**CHECK AND SET IGNITION TIMING IN ADVANCED POSITION
ELECTRA GLIDE / SPORTSTER / SERVI-CAR**

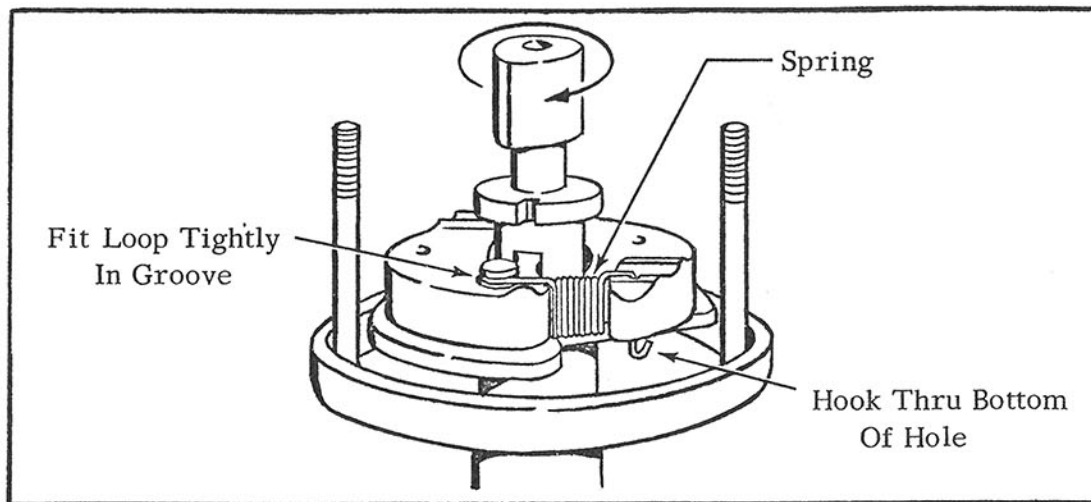
Although it has been the practice in the past to set the ignition timing in the retarded cam position on these models, it is now factory practice to set all production engines with circuit breaker cam fully advanced. Correct advanced timing is; 35° B. T. C. on Electra Glide, 45° B. T. C. on Sportster and 30° B. T. C. on Servi-Car models.

When checking or setting timing with a circuit tester or Strobe timing light according to procedure in Service Manual, ignition should occur when single mark on flywheel is in center of inspection hole in crankcase.

Note that cam must be turned clockwise with flyweights against stops, and held in this position while checking timing with a circuit tester. If a Strobe light is used engine must be run at 2000 RPM speed to be sure cam is fully advanced.
